SWIM PROJECT PROFILE		File No. : 194
Regist. No. : Agency No. : BSWM-113	Name: LABOON SWIP	
Region: 8	Province: SOUTHERN LEYTE	Municipality: MAASIN
Present Status: 1. Pre-F/S( )    ② F/S(1983)    ③ D/D(1983)		
Purpose: Major : Irrigation Incidental : IF, FC, WM		
Project Feature:

SWIM PROJECT PROFILE		File No. : 195
Regist. No. : Agency No. : BSWM-114	Name: POLANQUI SWIP	
Region: 8	Province: EASTERN SAMAR	Municipality: TAFT
Present Status: 1. Pre-F/S( ) ② F/S(1983) ③ D/D(1983)		
Purposo: Major : Irrigation Incidental : IF, FC, WM		
Project Feature:

SWIM PROJECT PROFILE		File No. : 217
Regist. No. : Agency No. : BSWM-137	Name: DUMADALIG SWIP	
Region: 11	Province: SOUTH COTABATO	Municipality: TANTANGAN
Present Status: 1. Pre-F/S( )    ② F/S(1983)    ③ D/D(1983)		
Purpose: Major : Irrigation Incidental : IF FC, WM		
Project Feature:

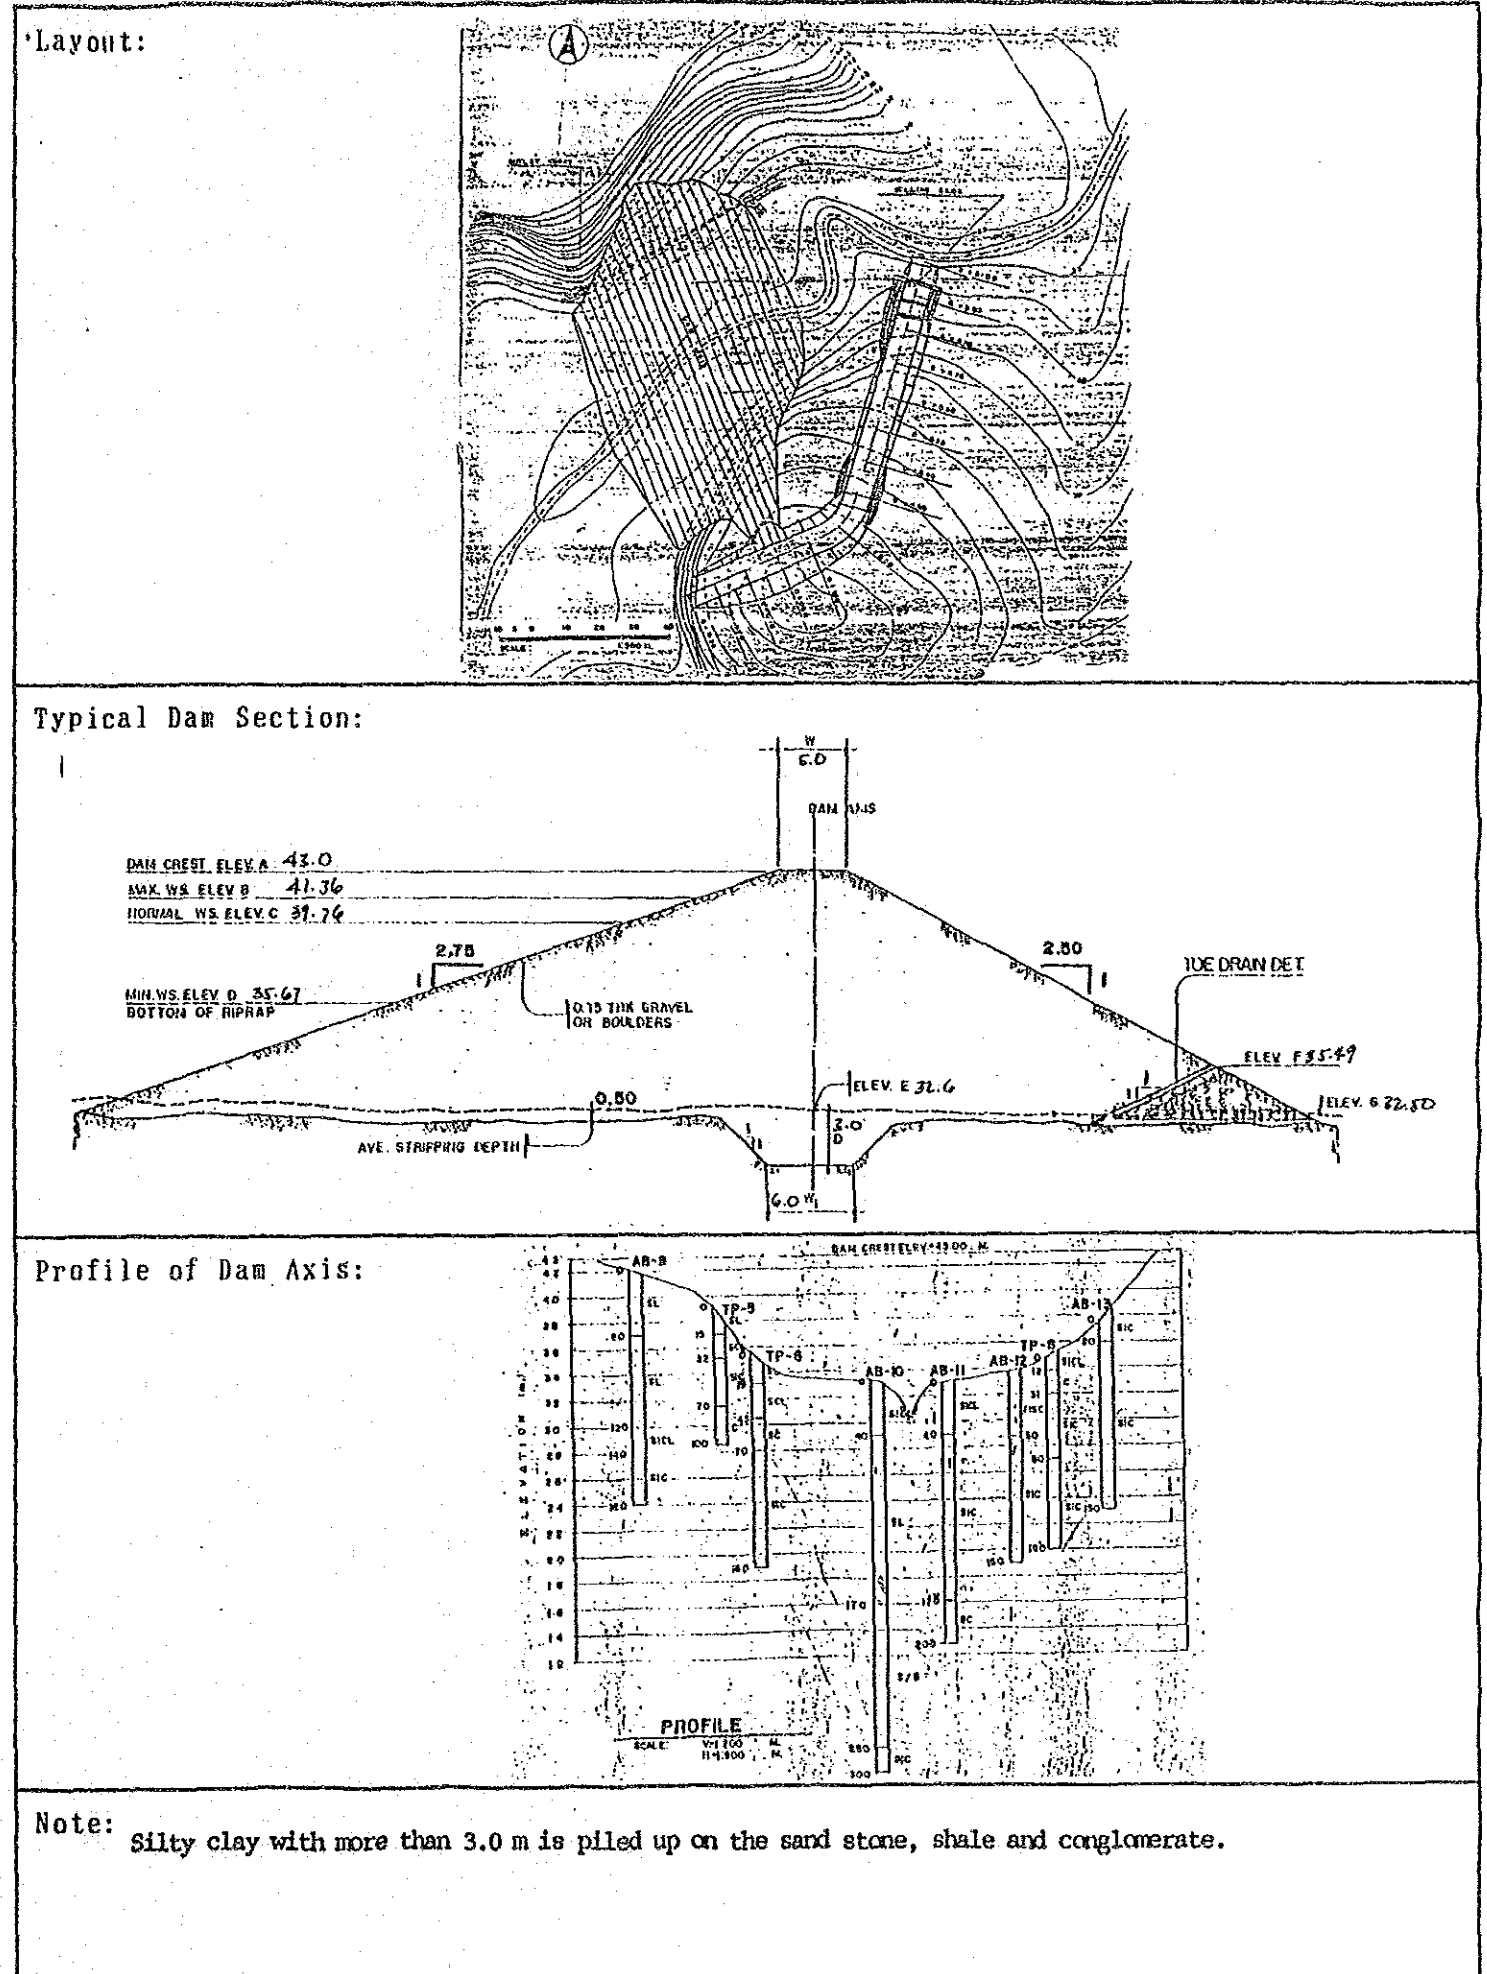
2. Planning Environmental conservation plan is not formulated.		
3. Design Depth of core trench shall be modified during construction. Stability of upstream slope of the dam shall be checked. Center line of the spillway shall be shifted to right side. Weir shall be provided in the spillway.

SWIM PROJECT PROFILE		File No. : 218
Regist.No.:	Name:	
Agency No.: BSWM-138	LIBASAN SWIP	
Region:	Province:	Municipality:
11	DAVAO DEL NORTE	NABUNTURAN
Present Status:	1. Pre-F/S( ) (2) F/S(1983) (3) D/D(1983)	
Purpose: Major	: Irrigation	
Incidental	: IF, FC, WM	
Project Feature:

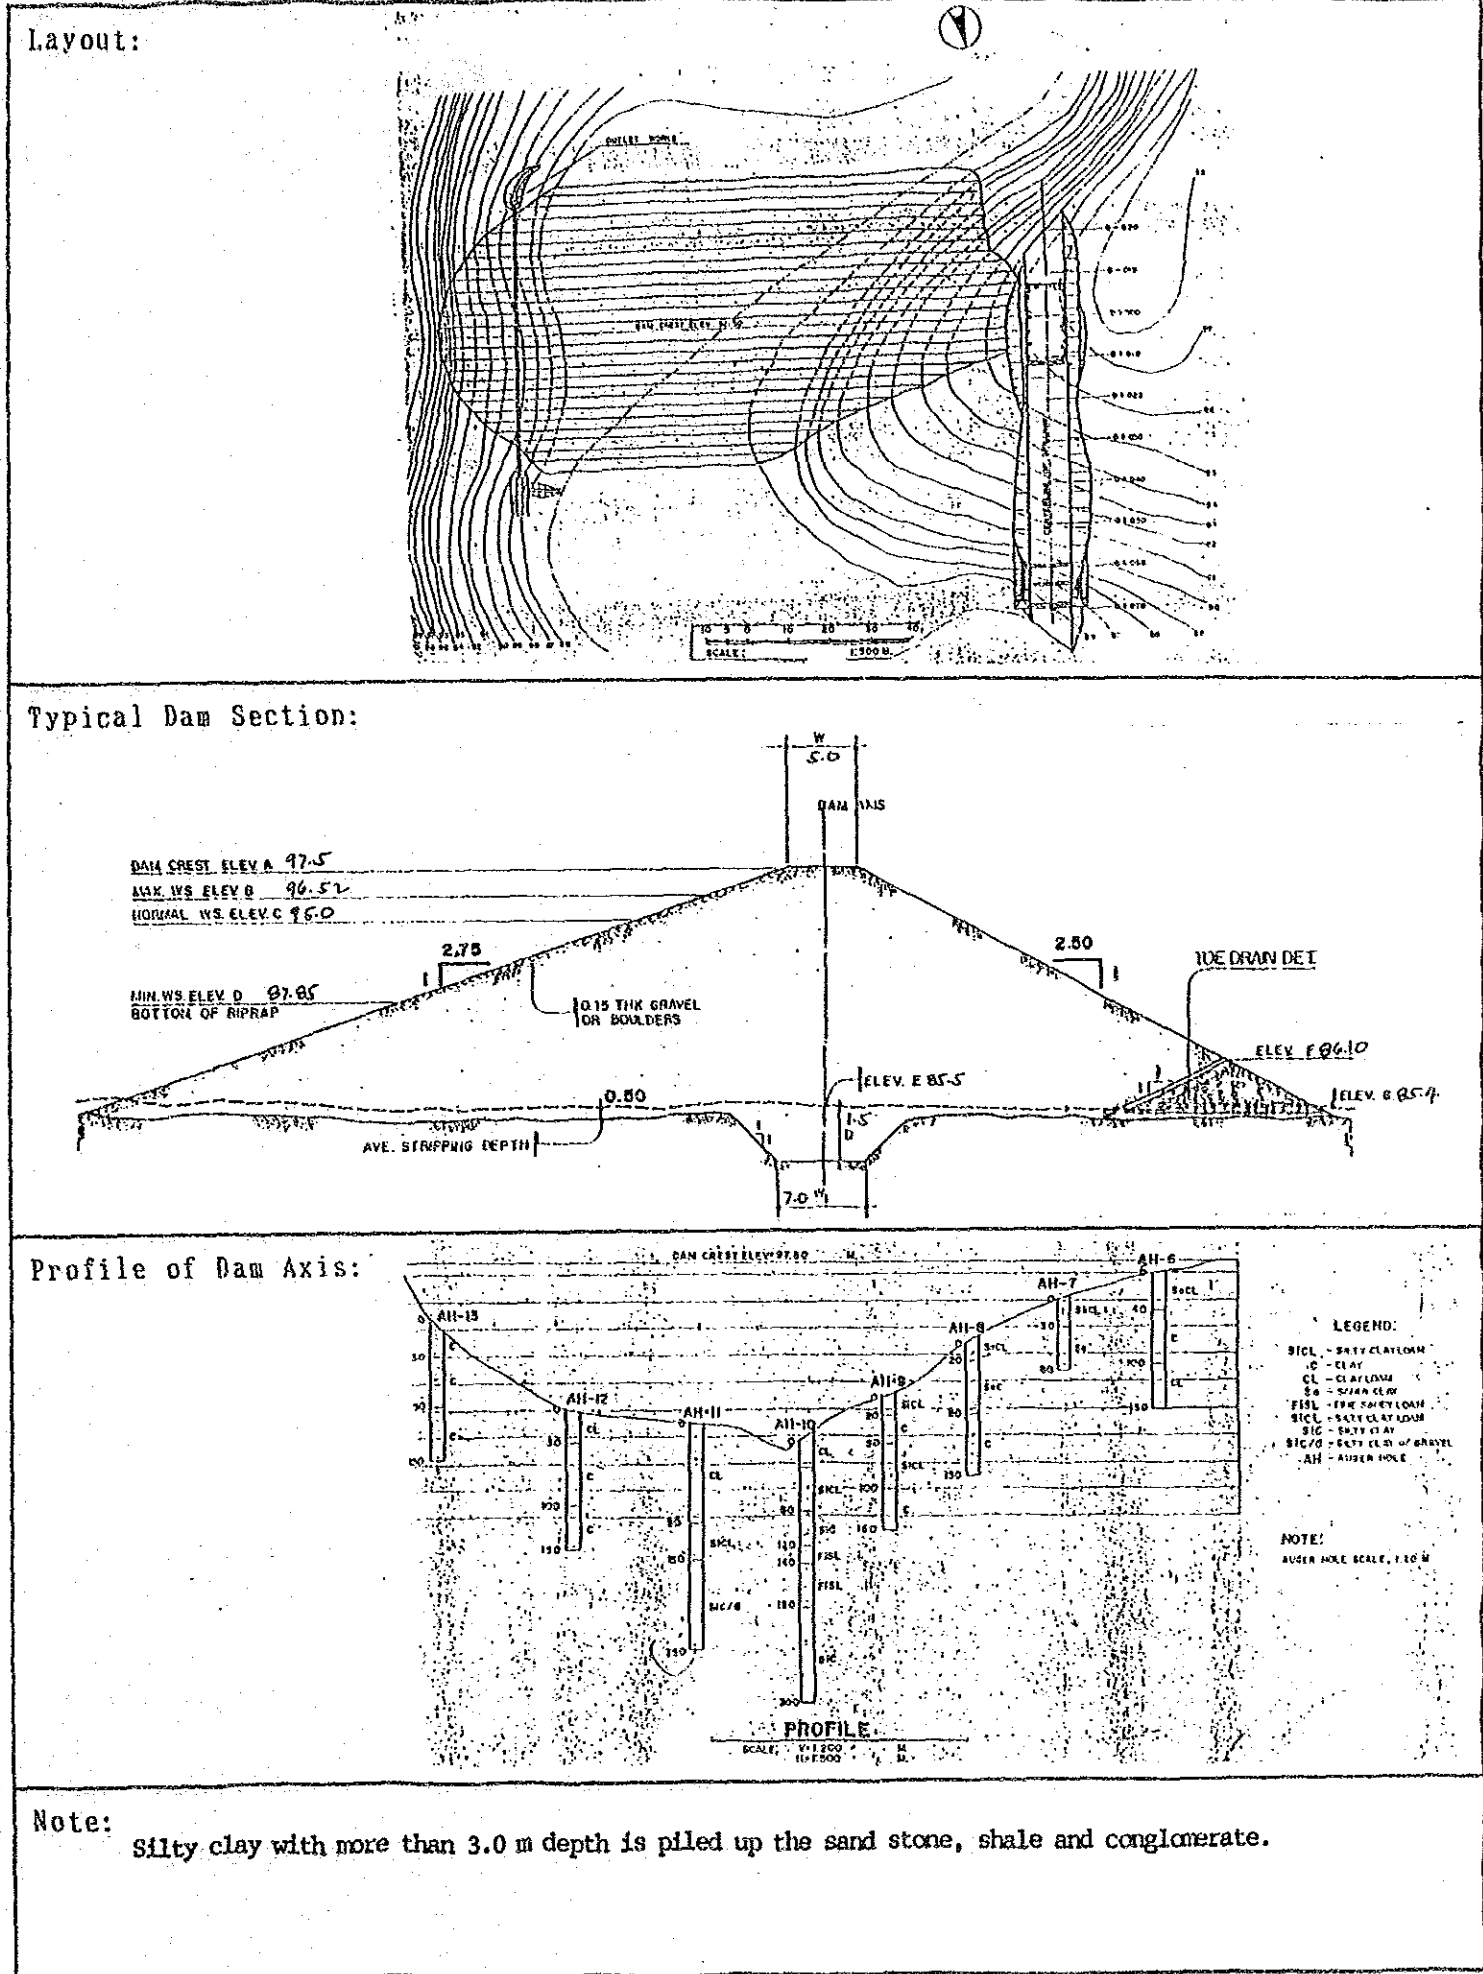
2. Planning	Environmental conservation plan is not formulated.	
3. Design	Depth of core trench shall be modified during construction. Stability of upstream slope of the dam shall be checked. Center line of the spillway shall be shifted to left side. Weir shall be provided in the spillway.

SWIM PROJECT PROFILE		File No. : 219
Regist. No. : Agency No. : BSWM-139	Name : FLORIDA SWIP	
Region : 11	Province : DAVAO DEL NORTE	Municipality : CAPALONG
Present Status: 1. Pre-F/S( )    ② F/S(1983)    ③ D/D(1983)		
Purpose: Major : Irrigation Incidental : IF, FC, WM		
Project Feature:

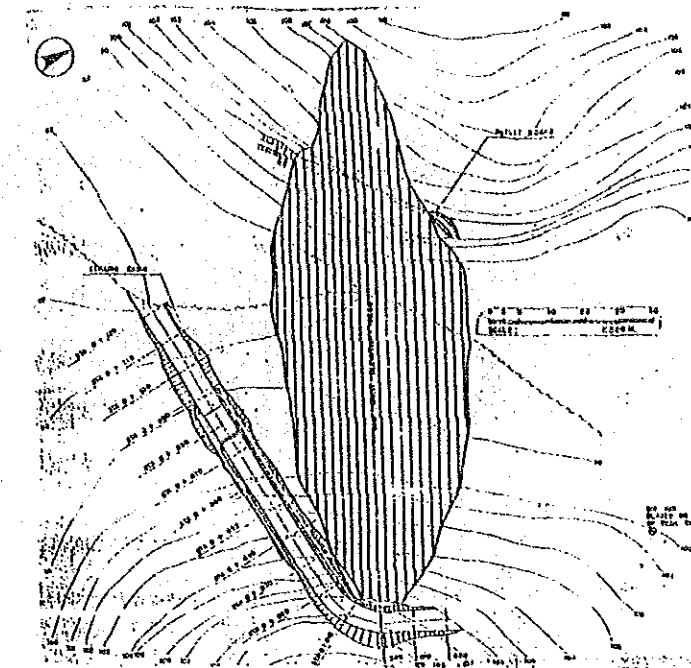
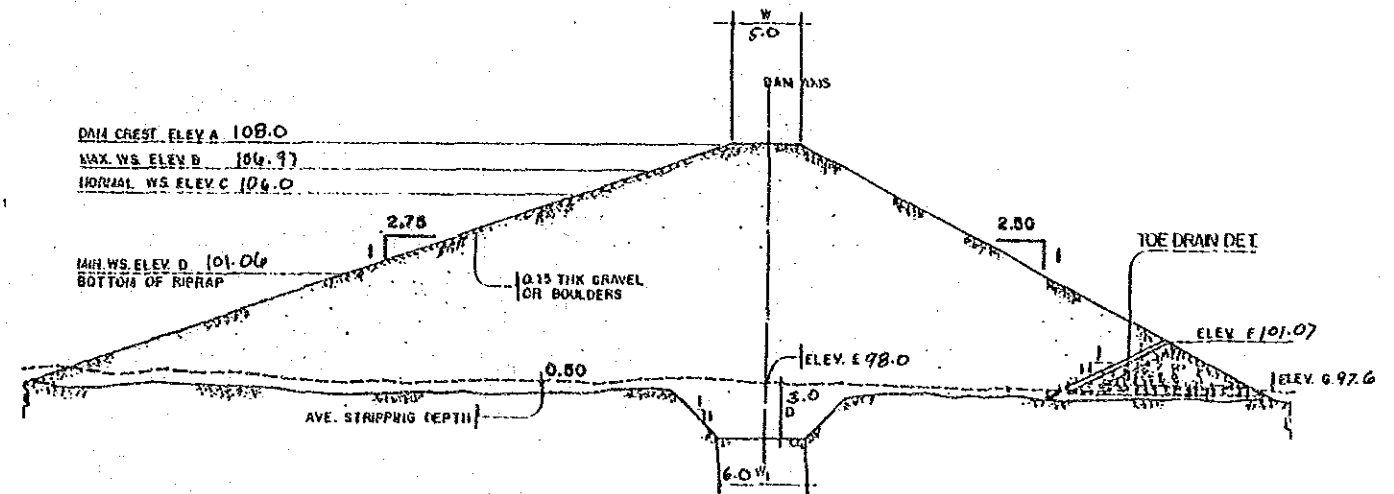
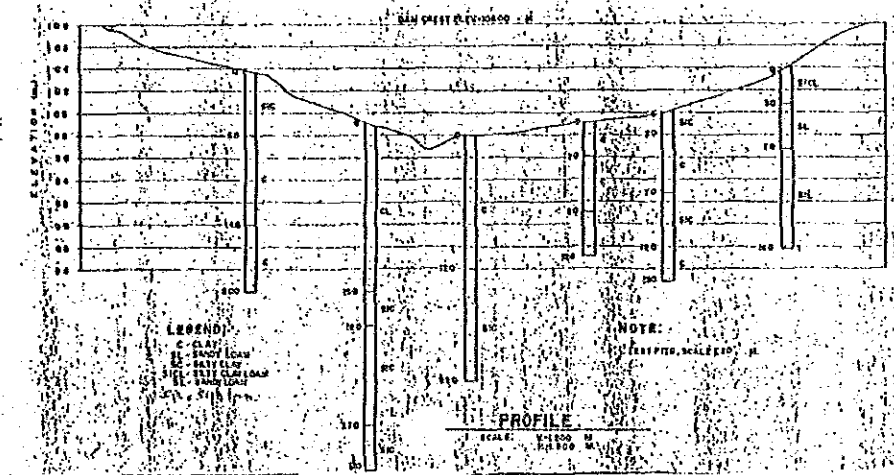
2. Planning Environmental conservation plan is not formulated.		
3. Design Depth of core trench shall be modified during construction. Stability of upstream slope of the dam shall be checked. Center line of the spillway shall be shifted to left side. Weir shall be provided in the spillway.

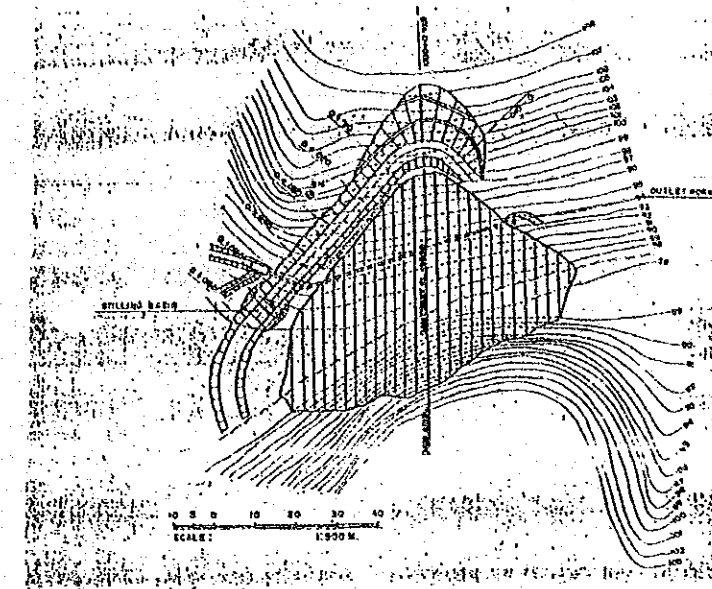
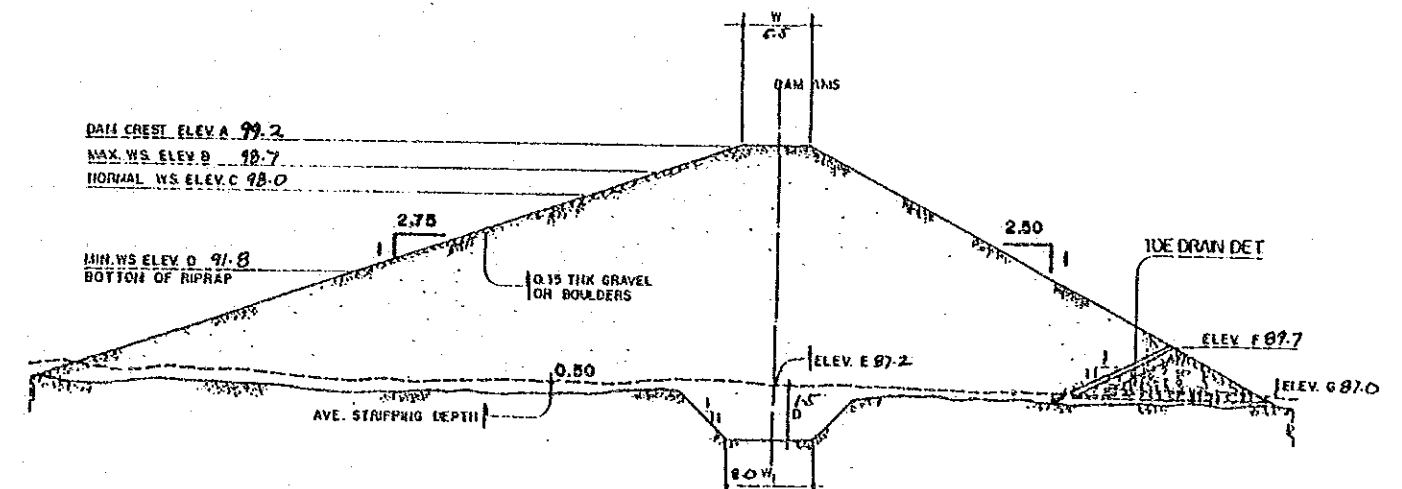
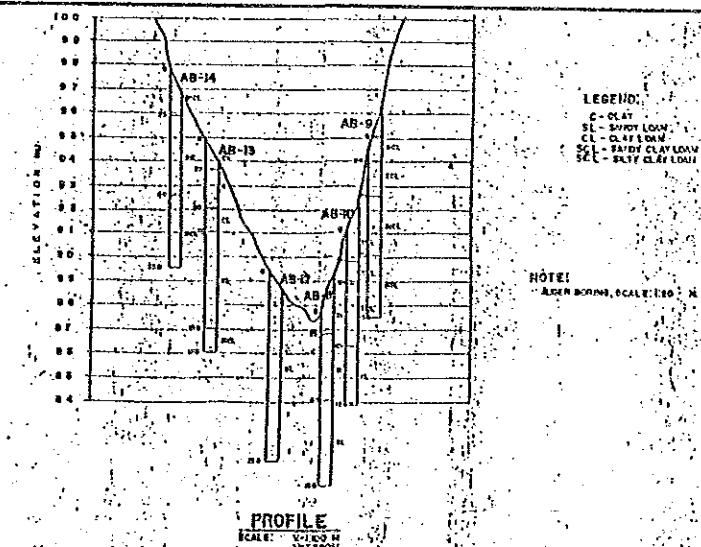
2. Planning Environmental conservation plan is not formulated.		
3. Design Depth of core trench shall be modified during construction. Stability of upstream slope of the dam shall be checked. Freeboard is not enough. Weir shall be provided in the spillway.

Note: Silty clay with more than 1.5 m depth is piled up on the sand stone and shale. Additional 0.5 m freeboard is necessary.

SWIM PROJECT PROFILE		File No. : 221
Regist. No. : Agency No. : BSWM-141	Name : SAN NICOLAS SWIP	
Region : 11	Province : DAVAO DEL SUR	Municipality : DIGOS
Present Status : 1. Pre-F/S( )    ② F/S(1983)    ③ D/D(1983)		
Purpose: Major : Irrigation Incidental : IF, FC, WM		
Project Feature:

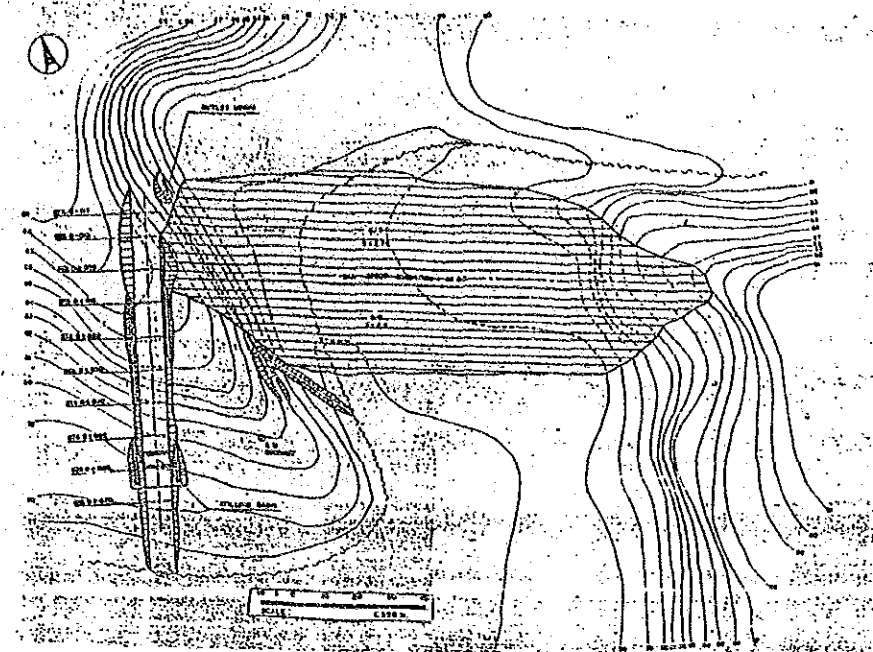
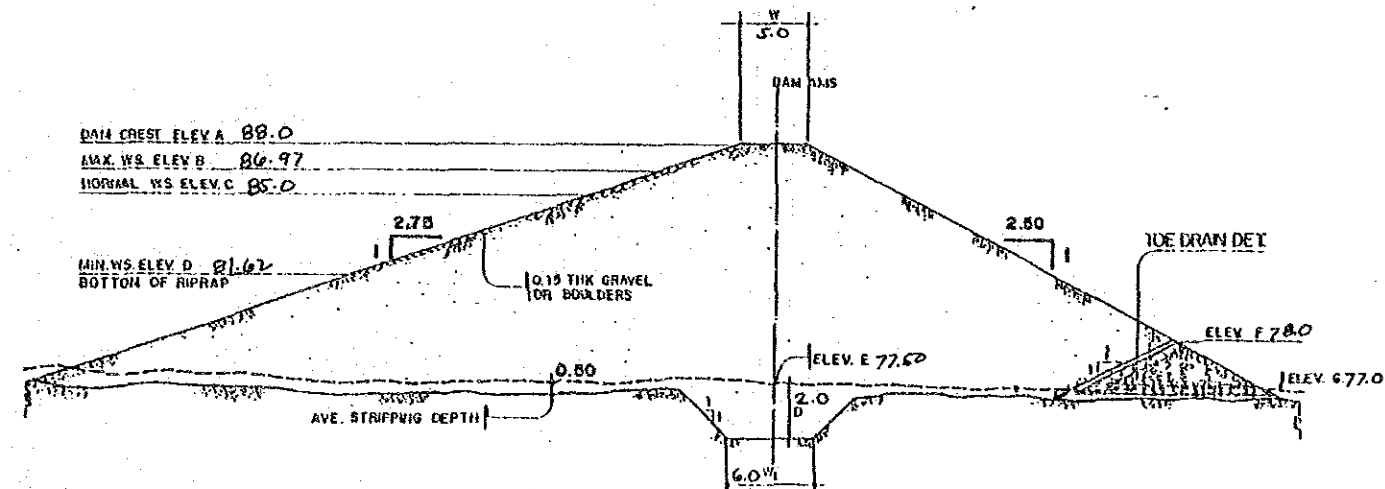
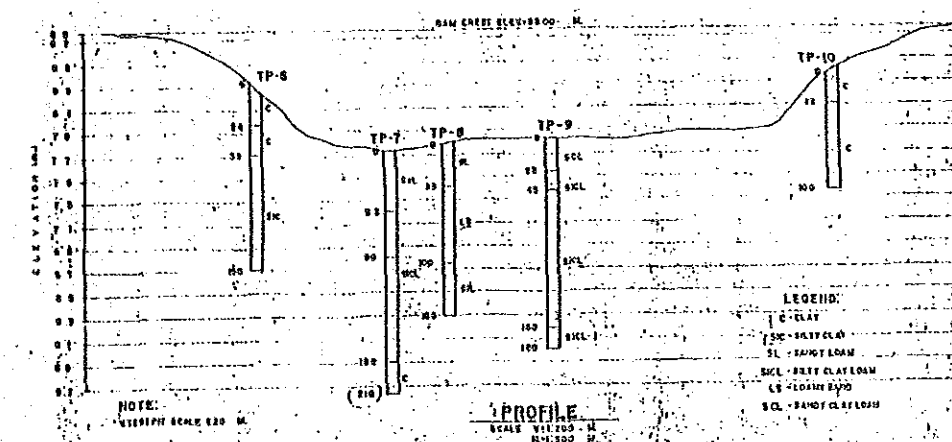
2. Planning		
Annual production of inland fishery is over-estimated.		
Environmental conservation plan is not formulated.		
3. Design		
Stability of upstream slope of the dam shall be checked.		
Center line of the spillway shall be shifted to right side.		
Weir shall be provided in the spillway.
